SUBJECT: REQUEST FOR ADDITIONAL INFORMATION LETTER NO. 304 RELATED TO  
DESIGN CONTROL DOCUMENT (DCD) REVISION 5

**Requests for Additional Information (RAIs):  
ESBWR Design Control Document (DCD) Revision 5 and NEDE-33374P, Revision 1**

Figure 4. Welds of the first level plain stainless steel to base plate

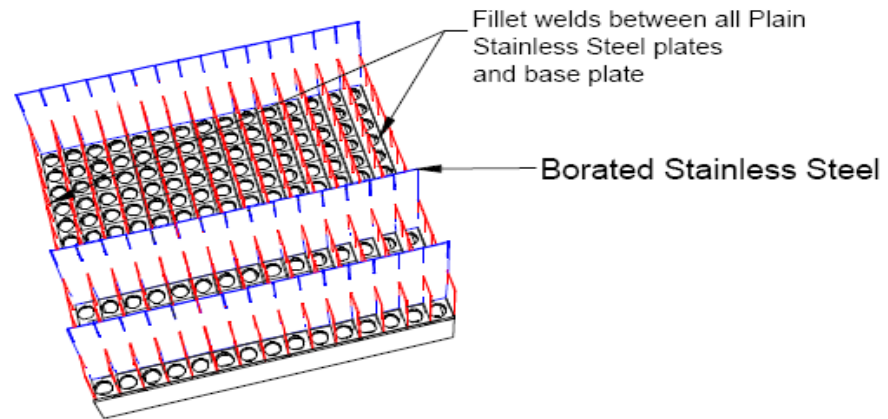
9.1-80 S01 (MFN 08-912, November 24, 2008)	Gilmer J	Provide additional justification for all assumptions and simplifications in the analysis.	The revised Section 3.0 represents a significant improvement over the original content of NEDC-33374P. However, all assumptions, approximations and simplifications should be identified and justified. [[
---	----------	---	---
